Texas Department of Housing and Community Affairs

Board Action Request

Presentation, discussion, and possible action regarding a Material Amendment to the Housing Tax Credit Application for Oaklawn Place (HTC #21136/22821/23935)

Re: Oaklawn Place Apartments, TDHCA #21136/22821/23935 CMTS #5791
 Notification/Amendment Request Items

1 SITE PLAN
1/8" = 1'-0"

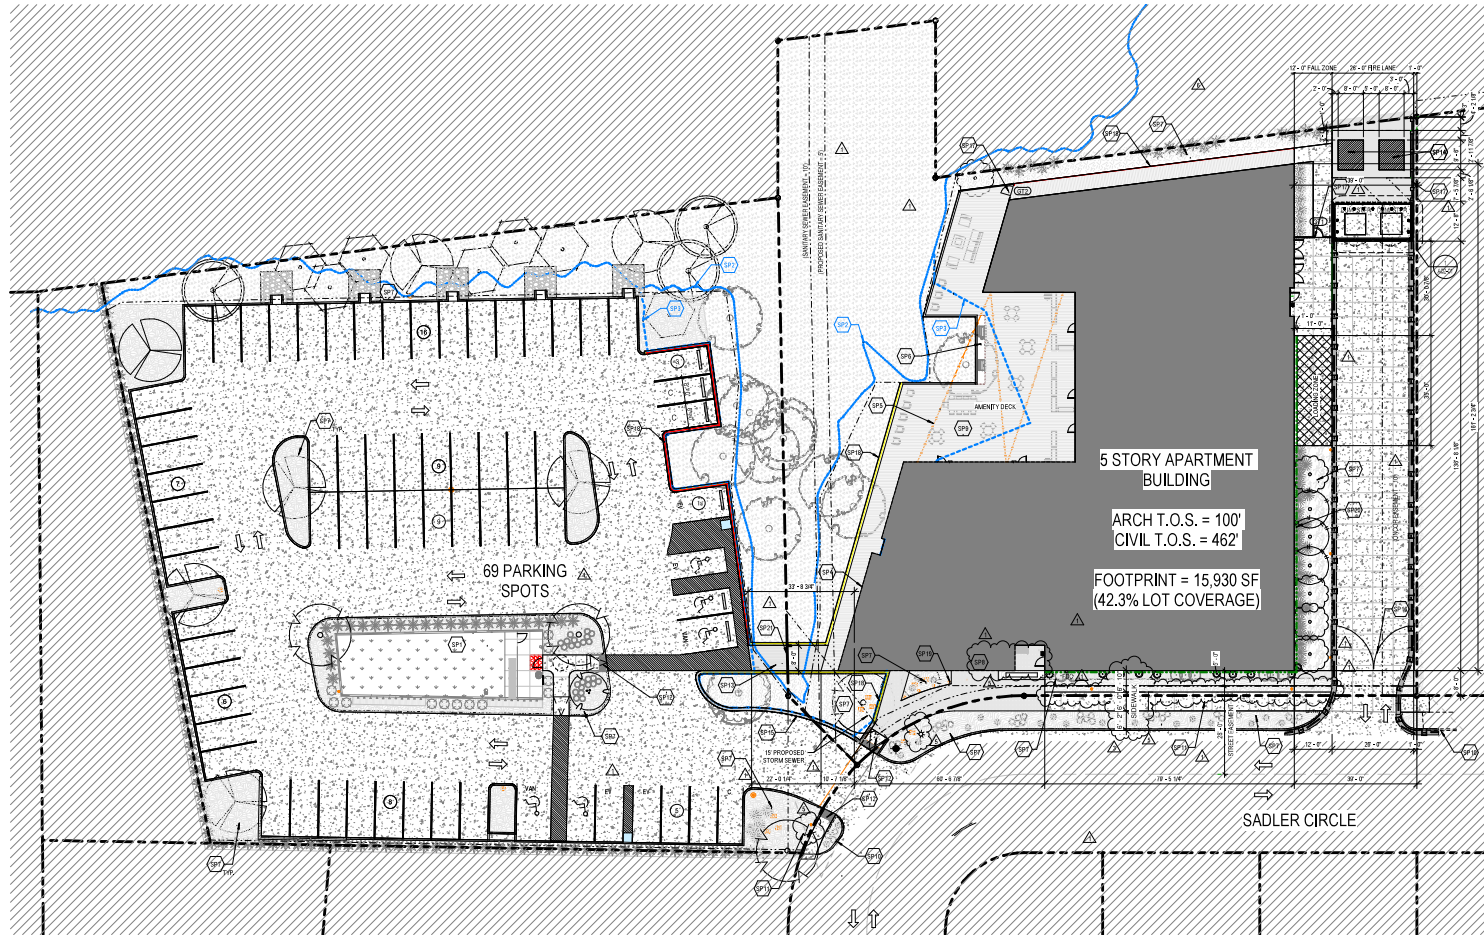
Reason for Change is Necessary: The changes in unit sizes were due to the change of the building design from an L-Shape submitted at Application to a slimmer C-shaped footprint to meet the following requirements:

- Comments by the City of Dallas fire marshal to provide a 12'-0" fall zone due at east side, adjacent to fire lane. The building was required to shift 12' westward to accommodate.
- Shorter path of travel at north perimeter to allow for fire-hose access to amenity deck.
- Loading zones at east side of building, within property line, in lieu of Sadler Circle entry due to restrictions by City of Dallas.

These changes to the overall footprint impacted the unit square footages as follows:

- Due to the narrower profile of the building footprint from site constraints, there was a slight reduction in square footage for the standard 1-bedroom Type 1-A and 1-B units.
- Due to the reconfigured form of the building, irregularly shaped units were developed for corner and edge conditions, with larger square footage and premium views.

Good Cause for Change: The changes were necessary in order to comply with the City of Dallas requirements for the 12’ fall zone clearance and relocation of drop-off/loading zone from Sadler Circle to within property line. In addition, the building footprint configuration allowed a shorter path of travel for fire-hose access. Due to the elderly target population, the tubs were all changed to showers per Owner request which will provide a more accessible option for residents.
